IMMINGHAM EASTERN RO-RO TERMINAL

Applicant's Response to the ExA's
Third Written Questions

Document Reference: 10.2.64

December 2023

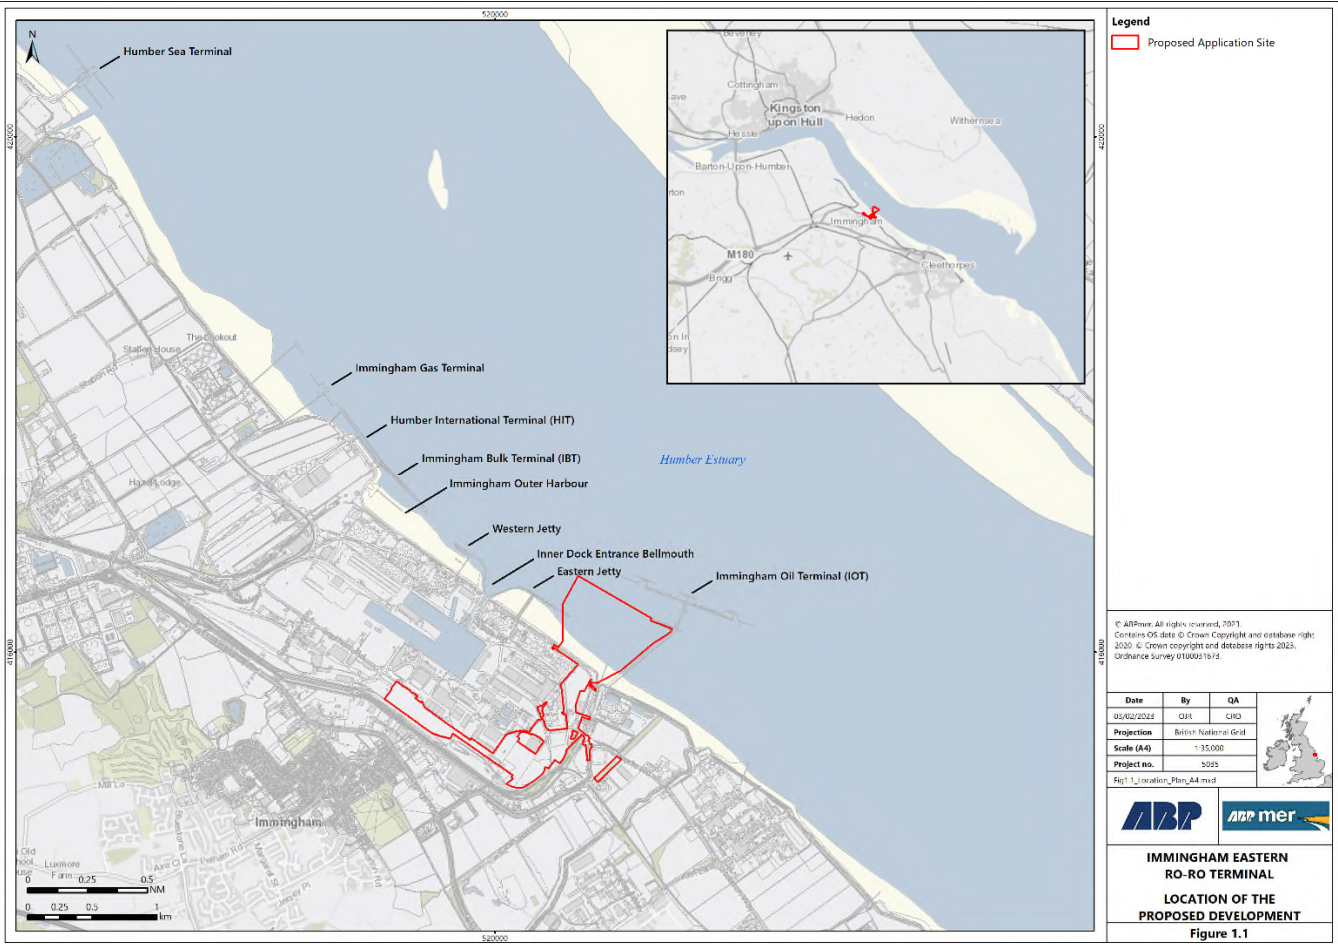
DCO.3.02	Applicant	<p>Requirement 8: Clarify marine safety responsibilities and duties in the outline Construction and Environmental Management Plan (oCEMP)</p> <p>In providing a marine oCEMP, further to Action Point 24 arising from Issue Specific Hearing 3 provide a further clarification of marine safety responsibilities in Table 3.4 in the oCEMP [REP5-018] either by subdividing tasks and duties into a greater number of rows or by providing an additional plan or appendix accompany the oCEMP.</p>	<p>Following ISH6, the Applicant has agreed to subdividing the CEMP into marine and onshore oCEMPs (see response to ISH6 Action Points 4,5 and 6 provided at (document reference 10.2.63). The marine oCEMP will be submitted by the Applicant no later than 15 December 2023 and further clarification will be given in Table 3.4.</p> <p>The note prepared jointly by the Applicant and HMH provided in response to ISH5 Action Point 6 (document reference 10.2.62) (which is submitted on behalf of HMH) provides a further explanation of the responsibilities of the SCNA and the SHA for the Port of Immingham.</p>
